TS-890S

Circuit update for antenna tuner failure.

SERVICE BULLETIN ASB-0167

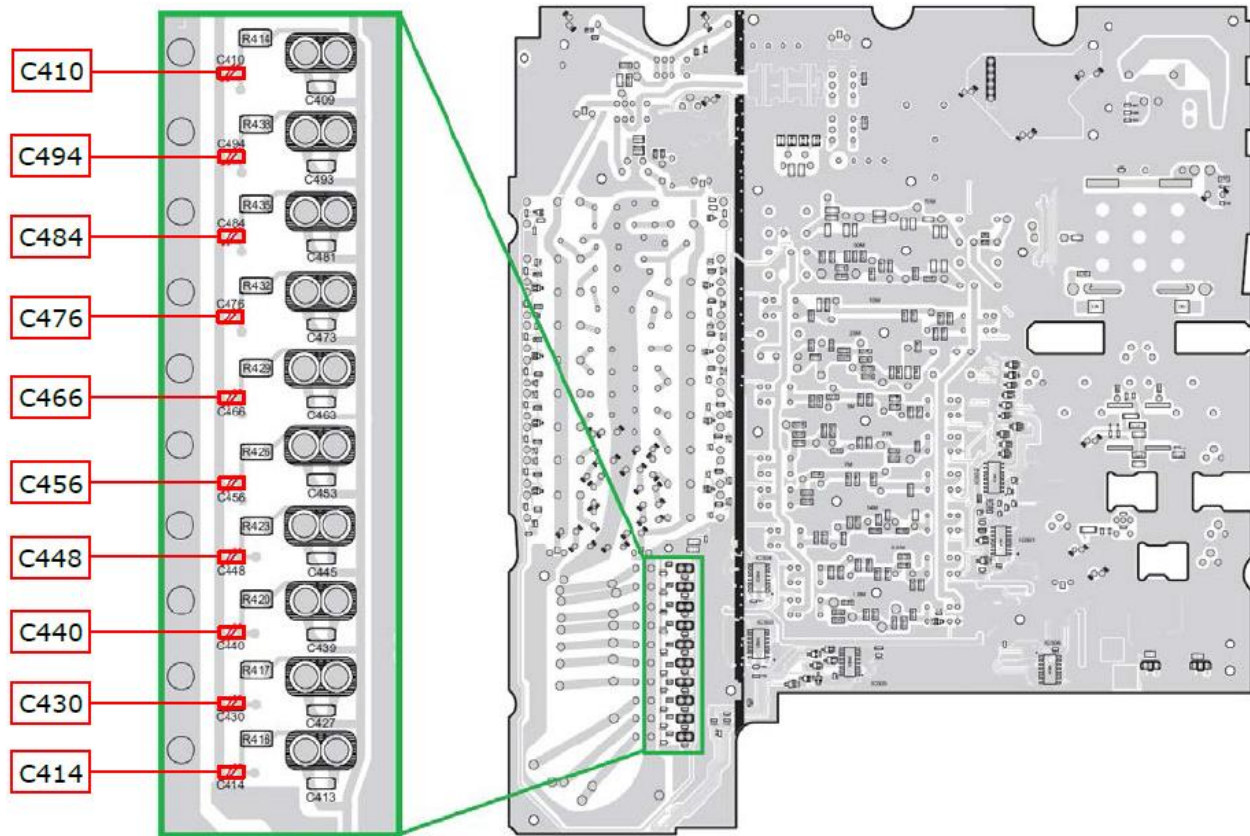
Remove all the following 10 chip capacitors (CK73GBB1H103K) from bottom side of Final/AT unit PCB

When a TS-890S Antenna Tuner circuit is repaired by replacing the relay control transistors part number DTD113ZU (mainly Q510, Q511, Q512), please also remove the chip capacitors as follows to prevent recurrence of the ATU failure.

1. Remove all power sources from TS-890 and all external connections from rear and front panels
2. Remove upper cabinet lid and RF shield to expose Final/AT Unit PCB
3. Remove Final/AT unit PCB from the chassis to expose the circuit update area on the bottom side of the PCB
4. Remove 10 small chip capacitors shown in the following picture
5. Suggest using 2 soldering irons to avoid damage to the PCB. First apply solder on both sides of each capacitor then use both soldering irons at the same time to heat the solder points of the capacitor and move it from its location
6. Caution: If the capacitor is forcibly removed and the circuit trace is torn a repair will be required or the ATU circuit will not work
7. Check area is clear of any damage and remove any solder bridges / balls
8. Re-assemble unit
9. Test ATU is operational on all bands
